Work Plan Addendum - Proposed Feasibility Testing

Douglas Parking 1721 Webster Street Oakland, California 94612 ACHCSA Site # 4070 Cambria Project # 580-0197

Cross Section A - A'

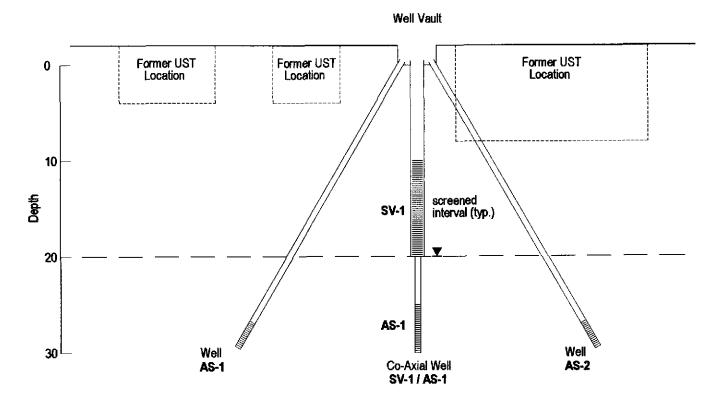
Our office would also like additional information regarding the proposed soil vapor extraction/air sparge tests, which we have previously approved. Please provide a cross-sectional diagram of the existing remediation wells and describe how each of the tests will be performed and evaluated. We understand that based upon the results of the tests, a recommendation for the most appropriate remediation will be made. These results may also affect our prior recommendation to not proceed with a three month biosparge test.

As described in Cambria's Feasibility Testing and Feasibility Study Plan dated February 2, 2001, one day of soil vapor extraction (SVE) / air sparge (AS) testing will be performed in the vicinity of the former USTs (Figure 1). A SVE test will be performed on well SV-1 and a combined SVE/AS test will be performed on wells SV-1, AS-1, AS-2, and AS-3 (Figure 1). See Cross Section A-A' (Figure 2) and the soil boring/well logs for well construction details and soil lithology (Attachment B)
